AGENDA
BAINBRIDGE ISLAND ROAD END ADVISORY COMMITTEE
SPECIAL MEETING

Fletcher Landing Proposed Road End Improvements Assessment

AECOM
710 Second Avenue, Suite 1000
Seattle, WA 98104

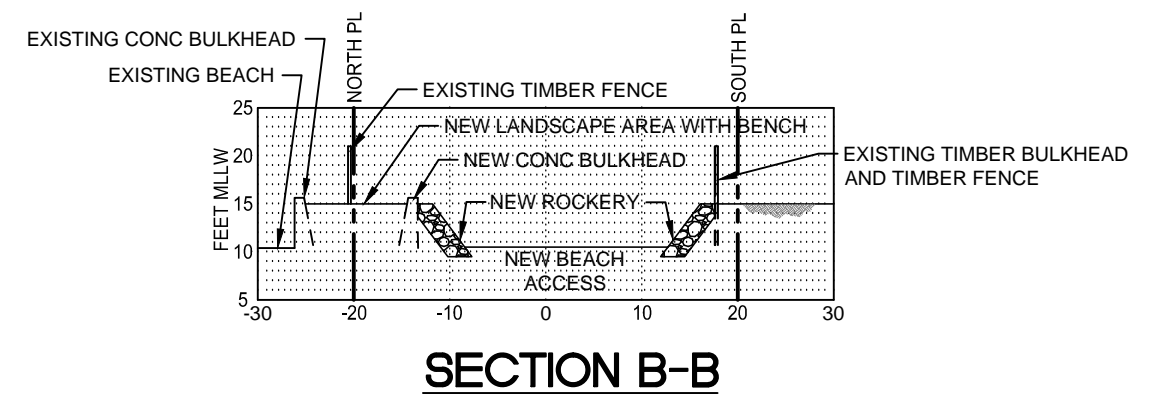
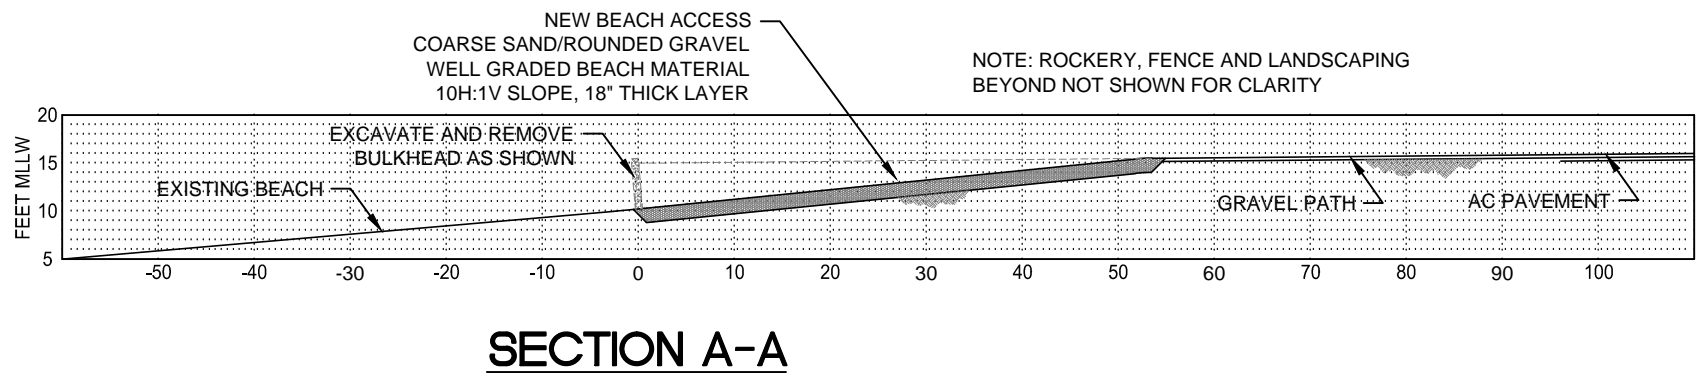
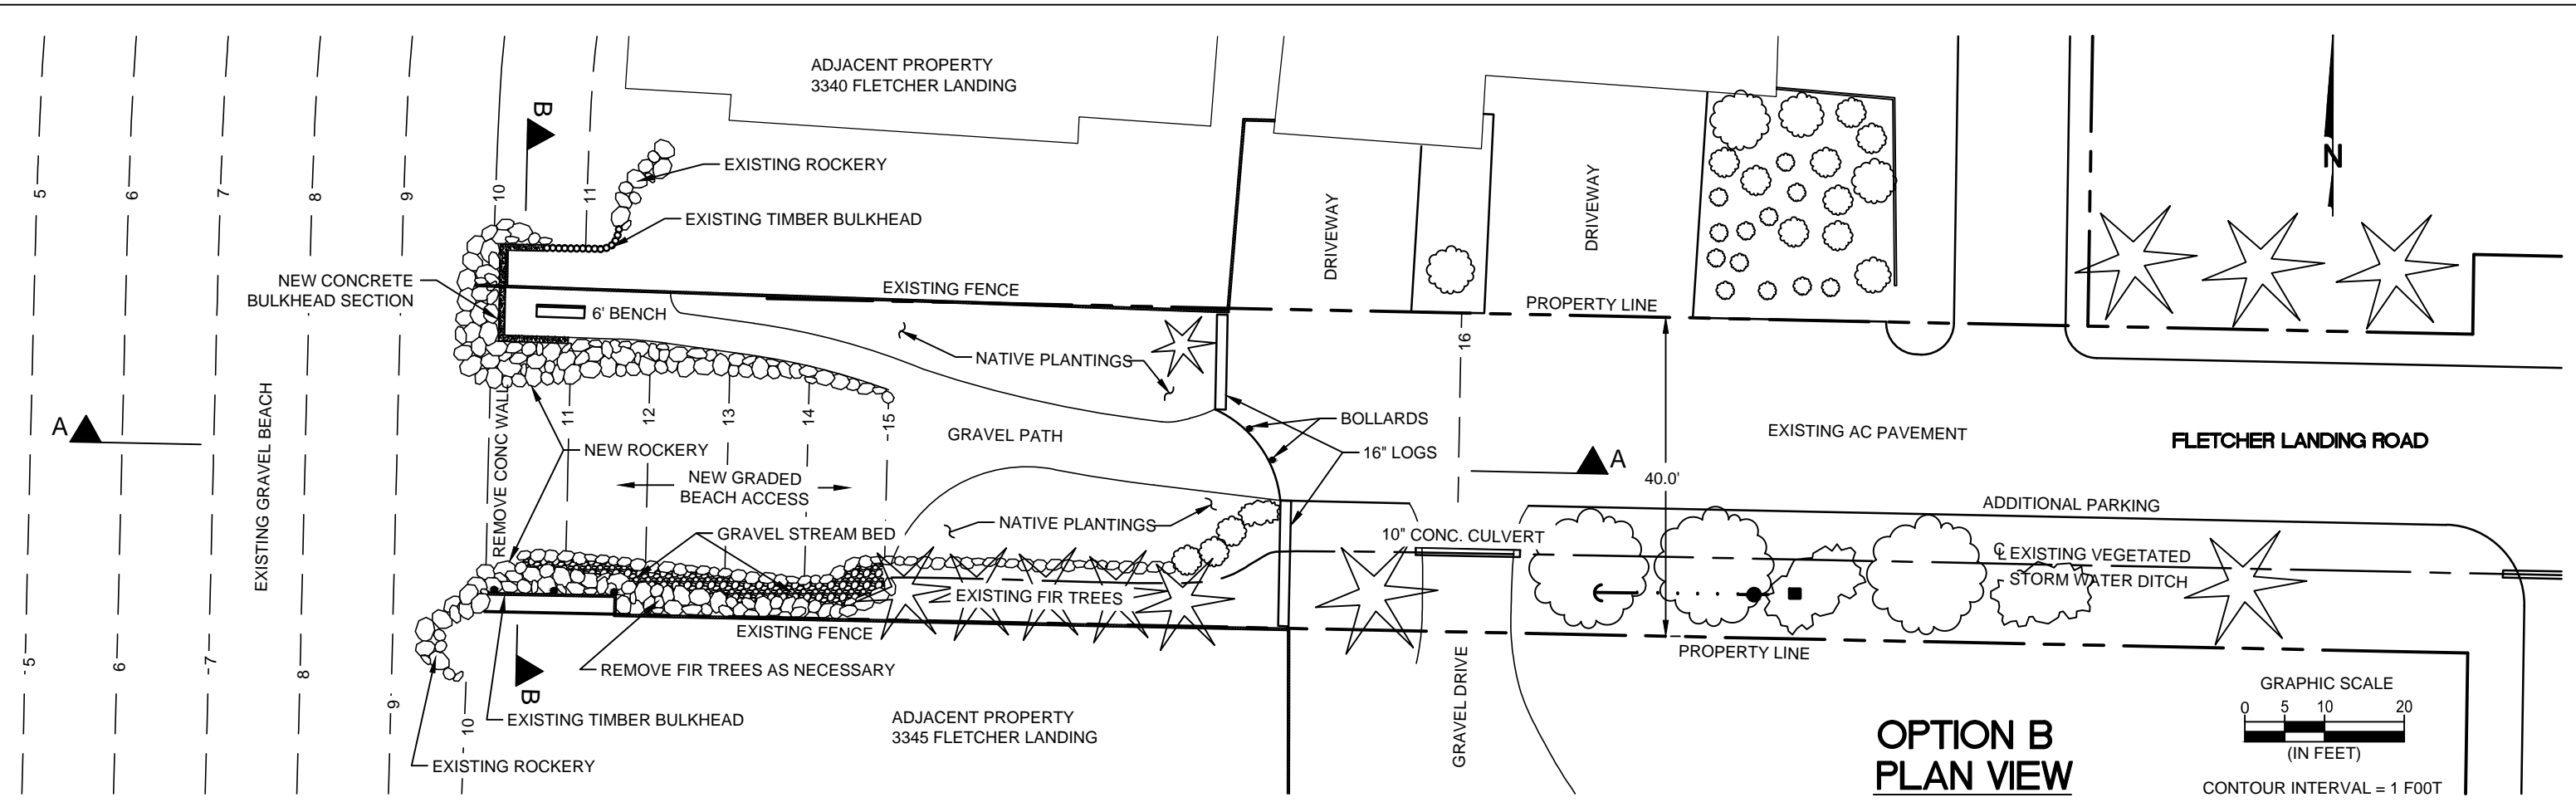
This option (Figure 7) provides the widest beach access with limited new upland landscape areas. The bulkhead is removed from the northern property line to its southern end. Existing grade is excavated to provide beach access by

carrying the existing beach up slope to tie into the existing upland elevation, creating additional beach area. Concept drawings show this beach extension at an approximate 10H:1V slope (final stable slope determined in design). It is assumed that material for the new extension of beach will be sized appropriately to blend with fronting beach and remain stable. Thickness of the new beach material layer is assumed to be 18 inches. New stone rockeries will protect the cut slopes along the north and south margins of excavation and tie into existing rockery to the south and bulkhead to the north.

This concept basically creates a well-protected pocket beach. Considering elevation range of new access beach and level of protection, erosion/stability of beach profile is not anticipated to present a significant design issue (for any of the options). Demolishing the seawall removes a vertical structure from the upper intertidal zone; this should provide some limited improvement in erosional conditions during the higher water levels by eliminating a reflecting surface for wave energy. No negative impact to adjacent shorelines would currently be anticipated (for any of the options).

Stormwater management for this option includes transitioning from the current open ditch to an 8 inch buried line at the 10 inch driveway culvert. The new pipe would enter a new catch basin with insert and then a buried discharge line extends west down the new access ramp and out to a beach discharge point at approximately elevation 8 feet within the intertidal zone. Additional more detailed design analysis is necessary to determine the area drained and amount of water to be conveyed during a design storm, and to determine the feasibility of an open vegetated bio-swale type system. Discharge at the rockery with an energy diffuser should also be explored as an alternative to the beach discharge.

This option provides two parking spaces as part of the street end redevelopment and, as with other options, there is room to park up to 4 vehicles along the south side of the road east of the gravel driveway.

Option A maximizes beach access and has the lowest level of park like amenities and landscape features. Maintenance for this alternative is anticipated to be minimal.

This alternative (as depicted) brings excavation and rockery construction right up to, or very close to, the adjacent property lines and property owners’ fences. Lacking information on fill/sub-grade material appropriate measure should be taken in design and construction to insure the integrity of fences and adjacent properties is maintained.

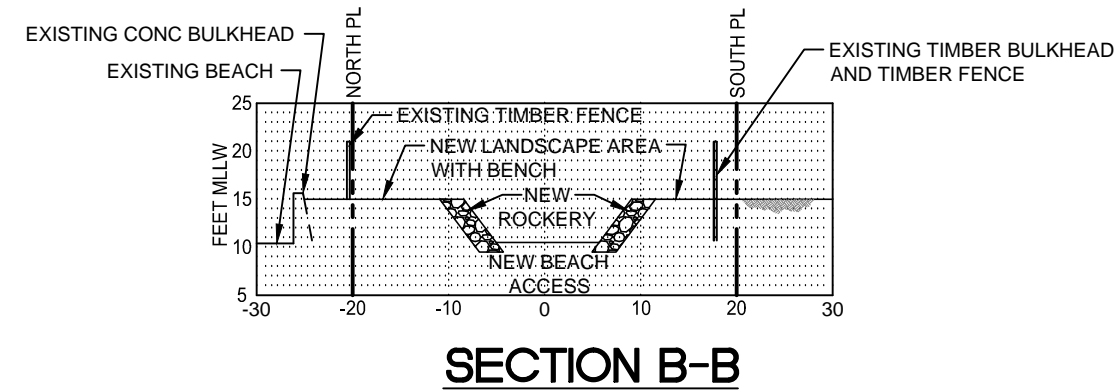
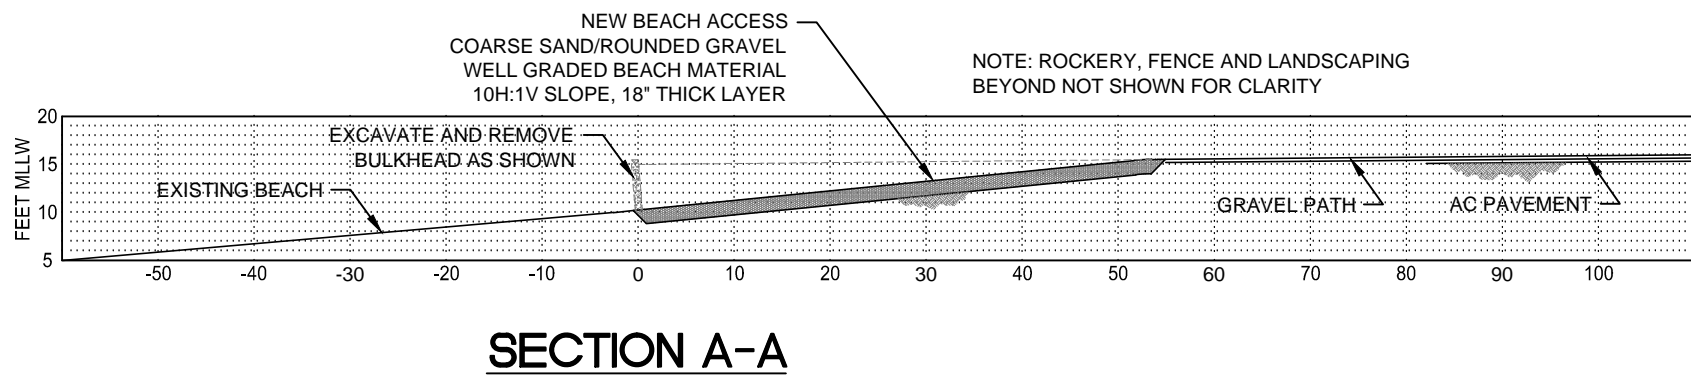
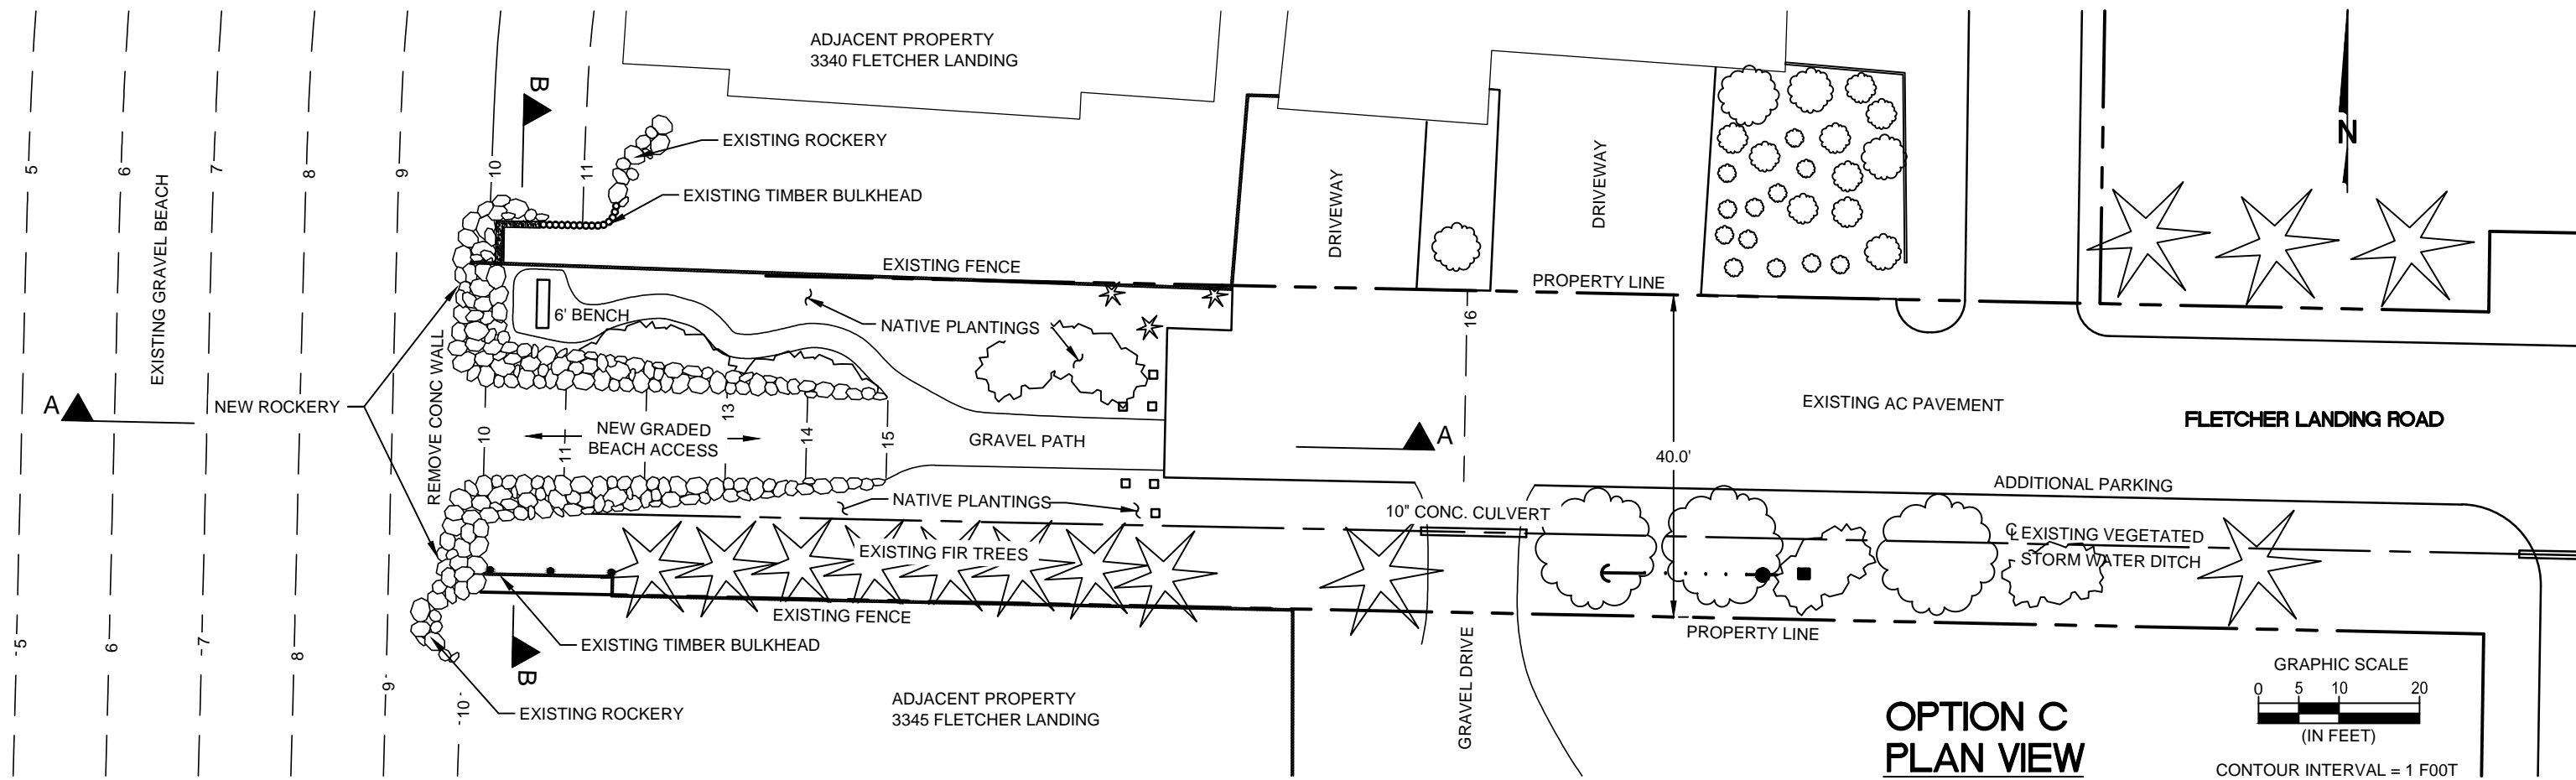
Option B (Figure 8.) follows the same basic concept as Option A but reduces the width of the beach access and provides a narrow landscaped area with a path and viewing bench at an upland grade along the northern edge of the site. A concrete bulkhead is constructed at the shoreside end of the viewing area.

Based on the concept sketch, it appears that Option B transitions the open stormwater ditch into an artificial gravel stream bed integrated into the rockery close to its base and discharges to receiving water. This is an interesting feature, but as with the other options, additional more detailed design analysis is necessary to determine the area drained and amount of water to be conveyed during a design storm, and the feasibility and compliance of the concept.

The concept sketch showed no parking spaces being created at the new street end but as with other options there is room to park up to four vehicles along the south side of the road east of the gravel driveway.

Option B reduces beach access width in order to provide a minimal level of park-like amenities, a viewing bench and landscape features. Maintenance for this alternative is anticipated to be minimal, limited to the care of landscaping.
